**Lots 305\_306**  
**Burswood Point**

A 10 Principle Design Report  
prepared by\_

# DRP 01 Responses

The following pages outline responses to feedback received during the Design Review Panel meeting held on 23/08/2023.

# L3 Planter Location

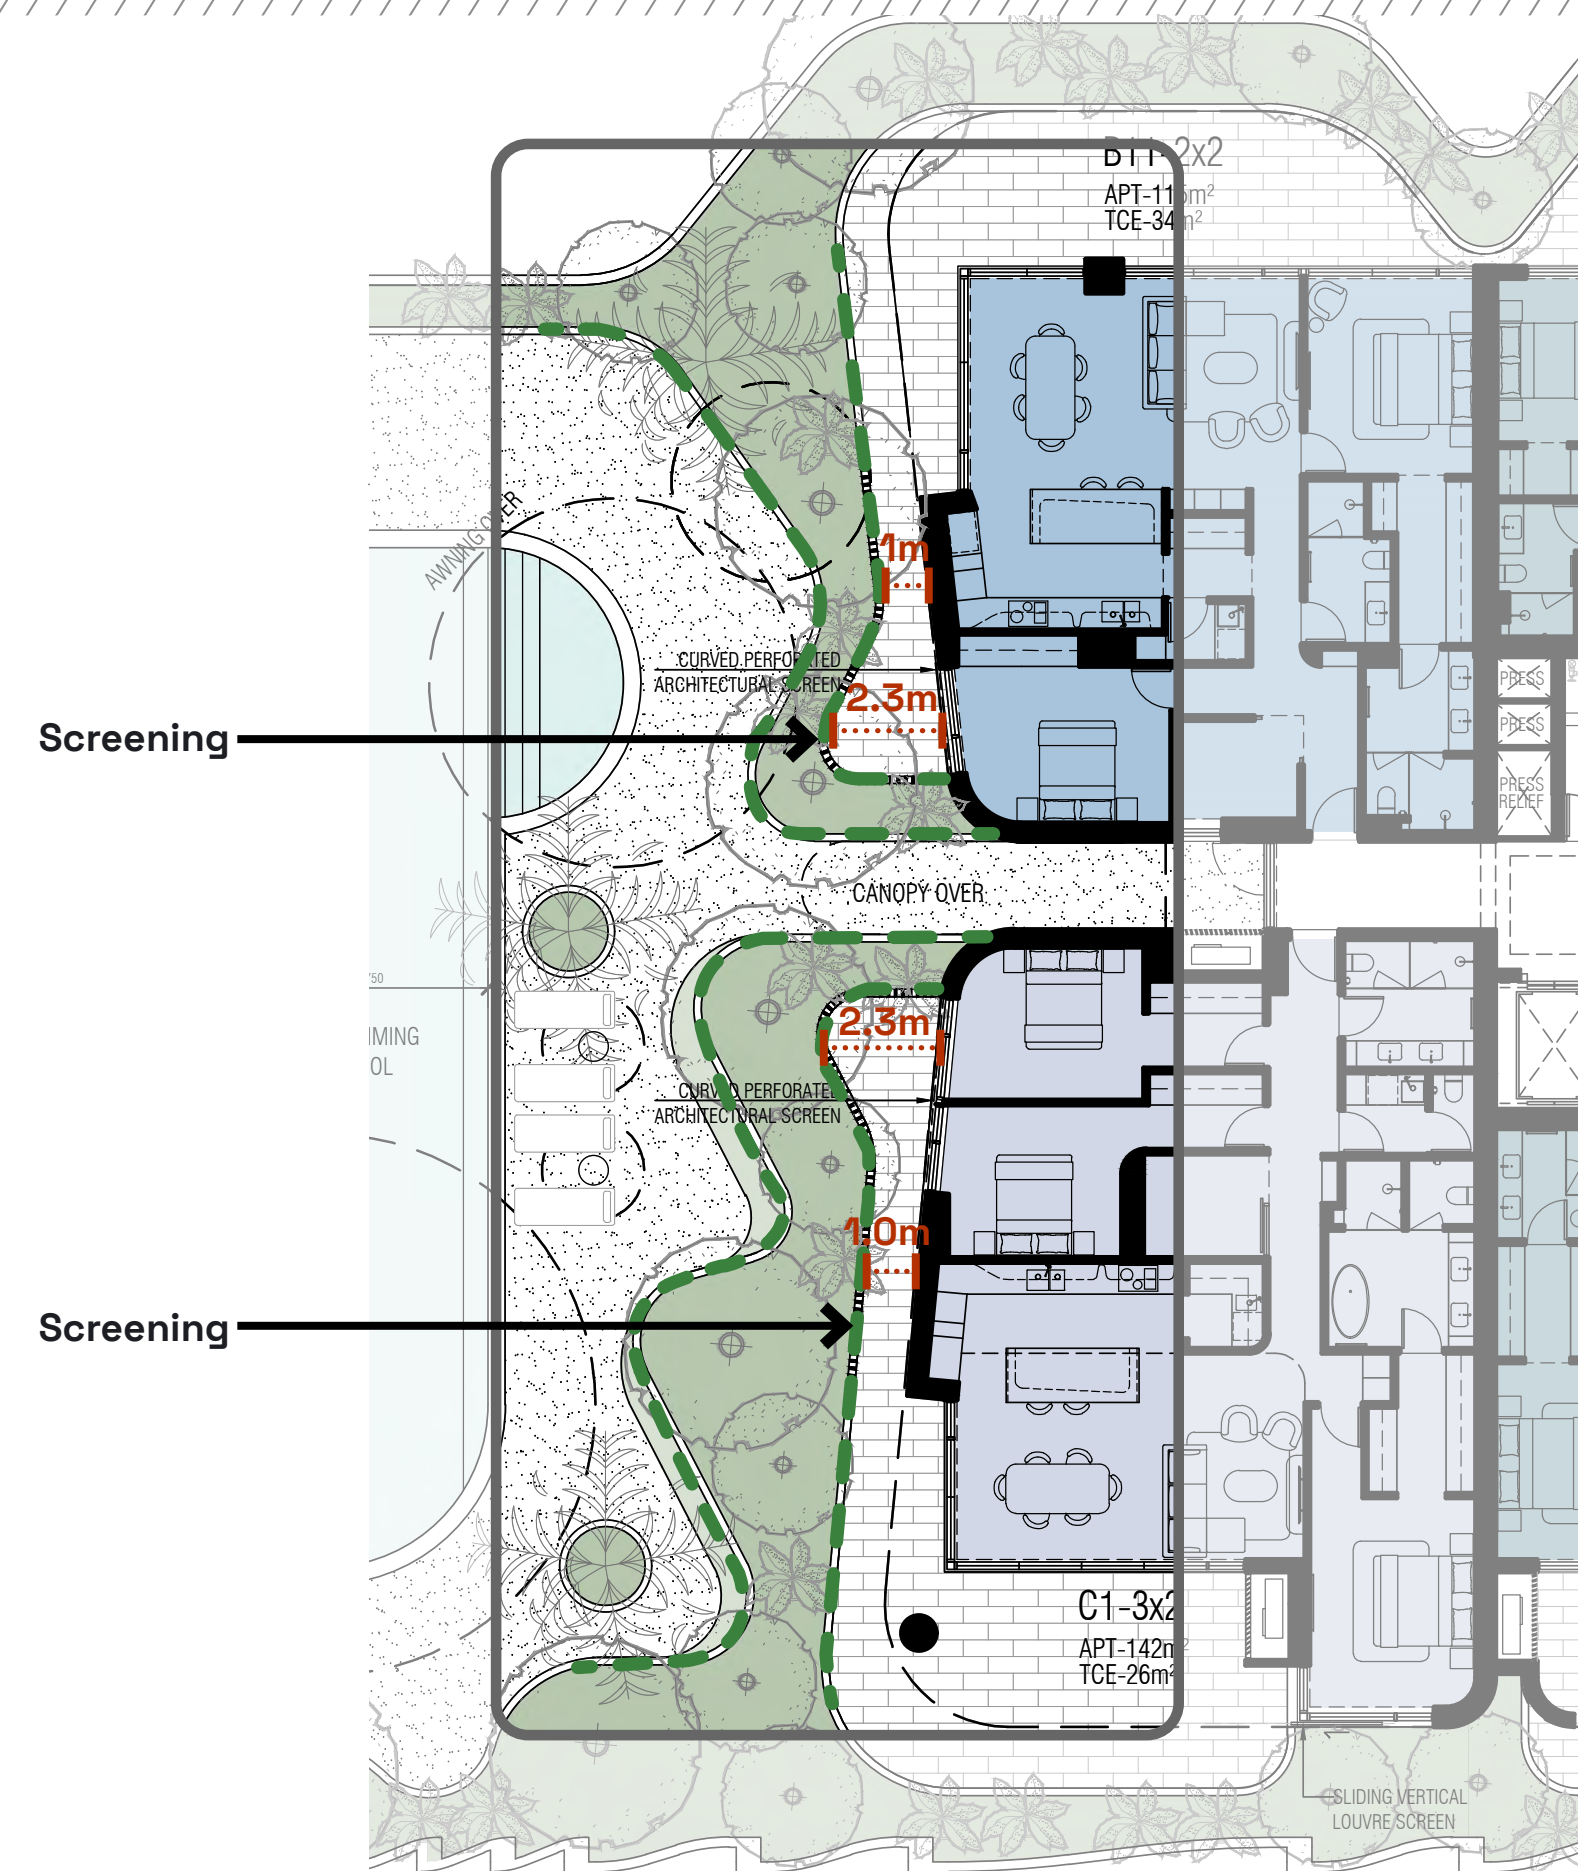
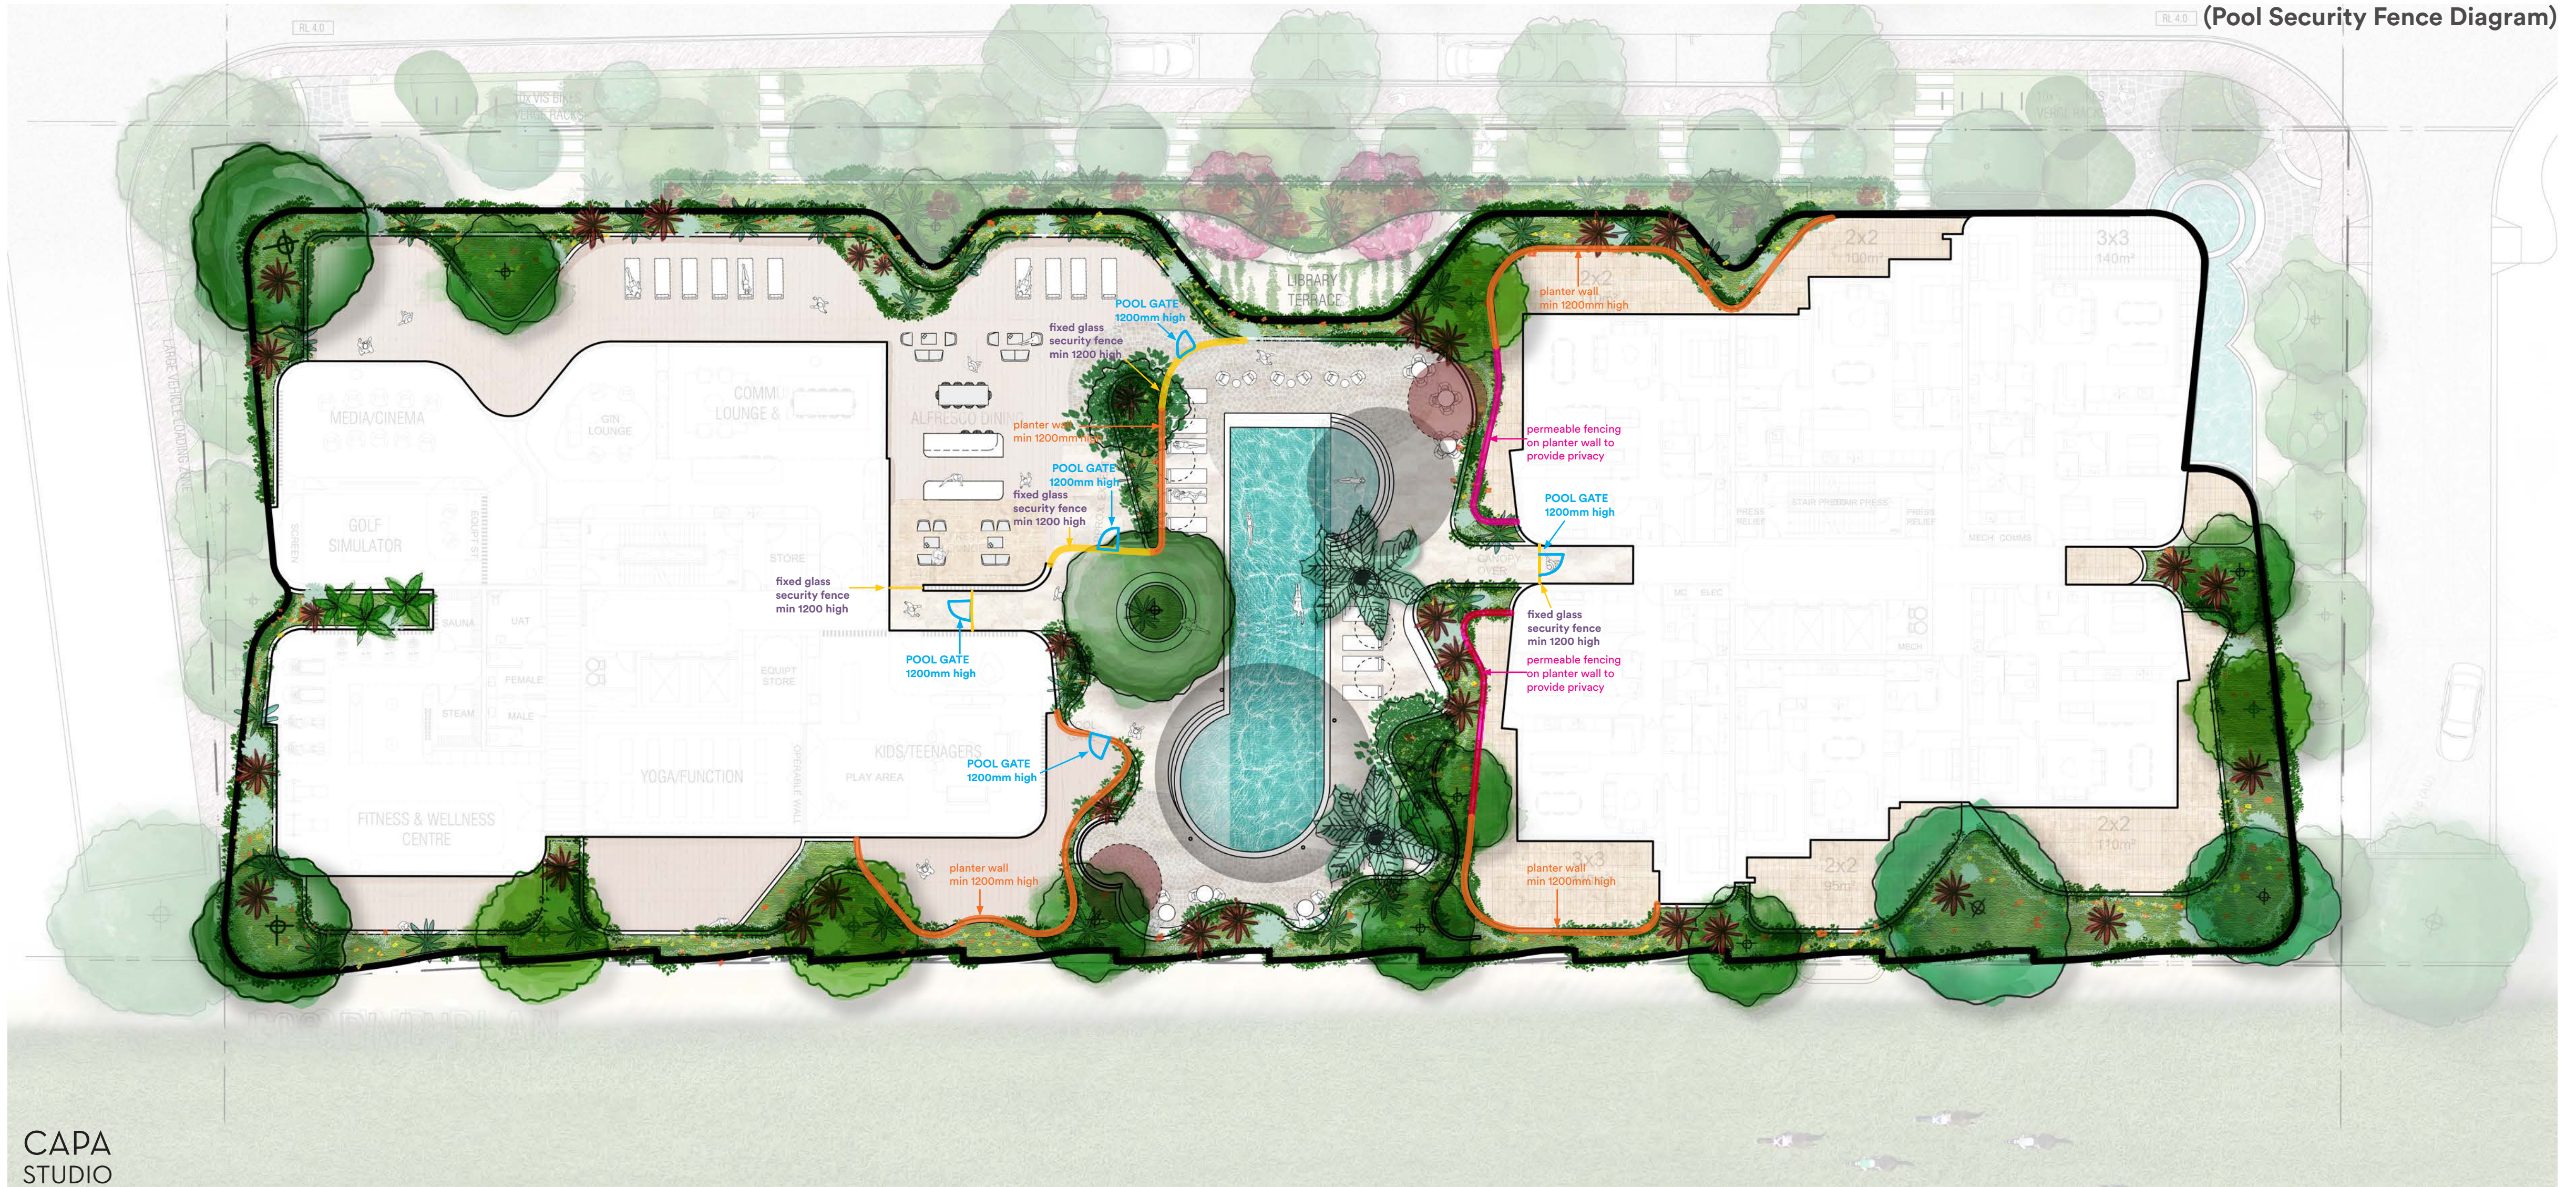
“Concern raised over the implication of a 1m high planter and planting located adjacent to bedroom windows on Level 3, eastern elevation.”

Refer to the following page “L3 Planter Location”.

- + Planters reconfigured to provide additional separation between bedrooms and the communal pool deck.
- + Revised terrace spaces for improved resident amenity.
- + Screening added for occupant privacy.
